## Product/Process Change Notification

<b>PCN Number:</b>	100018-A	<b>Product Category:</b>	Inker Hardware	<b>Issue Date:</b>	9-Nov-15
<b>Contact:</b>	Inside Sales	E-Mail: insidesales@xandex.com			
	1360 Redwood Way, Suite A	Phone: 707-763-7799			
	Petaluma, CA 94954	Fax: 707-763-2631			
<b>Description of Change to Customer:</b>					
Actuator mechanism redesigned to reduce the force required to actuate.					
<b>Reason For Change:</b>					
Improve reliability and increase period between required Preventative Maintenance actions.					
<b>Customer Impact of Change and Recommended Action:</b>					
Verify actuator mechanism does not impact specific customer use model.					
<b>Forecasted Key Milestones:</b> Subject to change based on business conditions					<b>Date:</b>
<b>Complete Internal Qualification Testing</b>					Complete
<b>Samples Available To Order</b>					Now
<b>First Shipment of Changed Product</b> (as early as)					9-Feb-16
<b>Last Shipment of Unchanged Product</b> (subject to material availability)					8-Feb-16

PCN #100018

Current TEL P8 Actuator

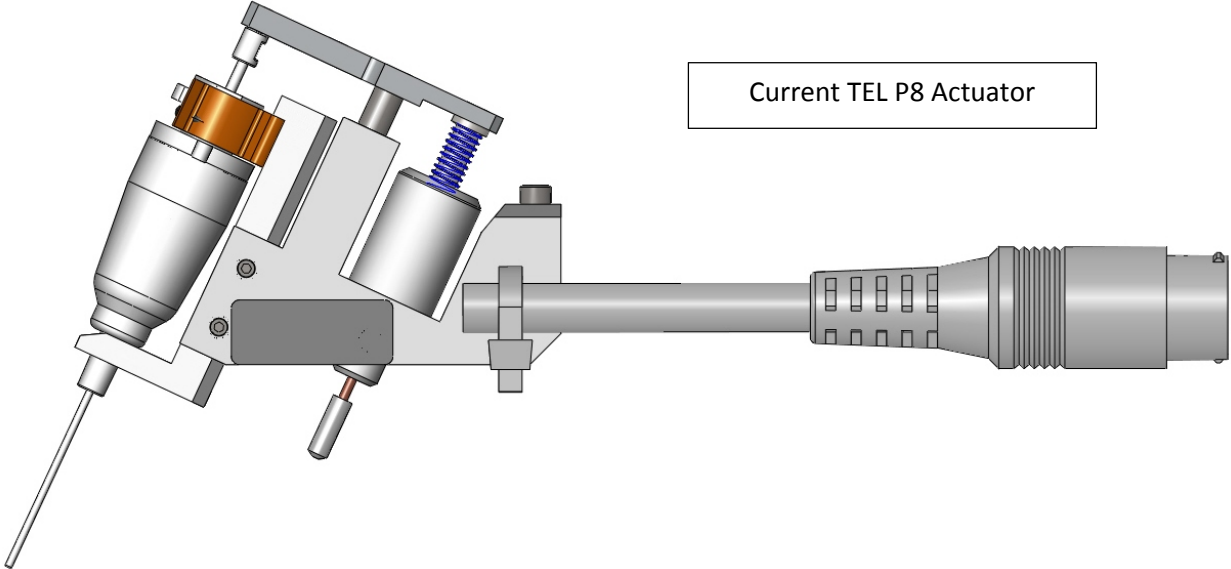
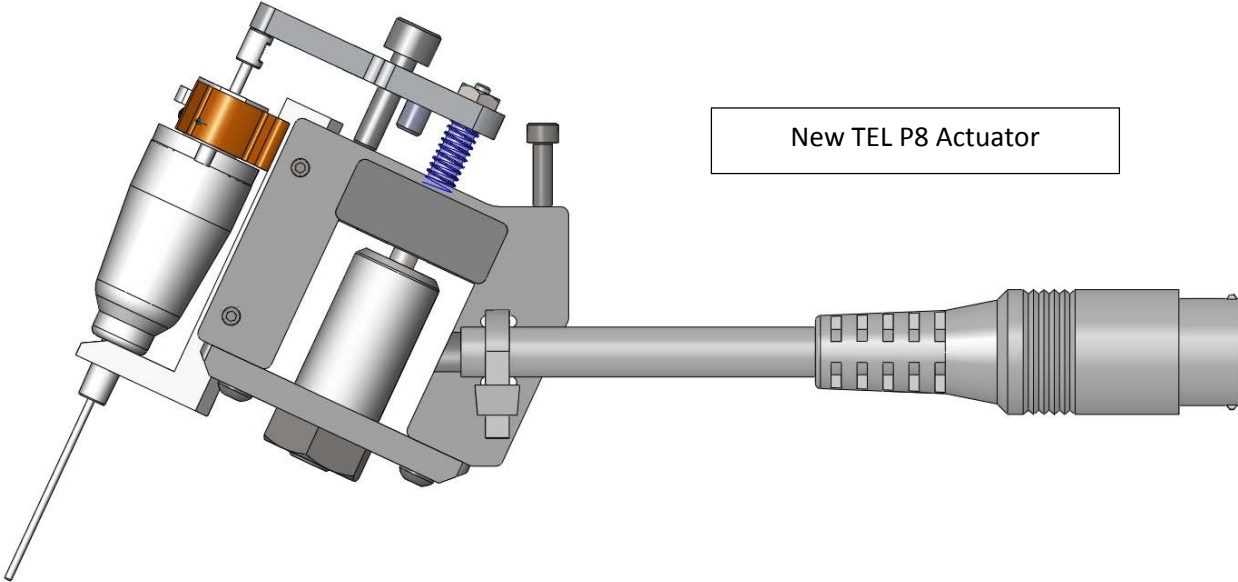
<b>Method of Identifying Changed Product:</b>					
Visually different (see accompanying pictures)					
<b>Assessment:</b>					
Change in function (actuation time), form (see accompanying pictures)					
<b>Products and Xandex Part Numbers Affected</b>					
Retrofit Cartridge Holder      315-0008   315-0010   315-0011					
<b>Revision History</b>					
<b>Date of Revision:</b>	<b>Revision Letter:</b>	<b>Reason:</b>			
9-Nov-15	A	Initial publication
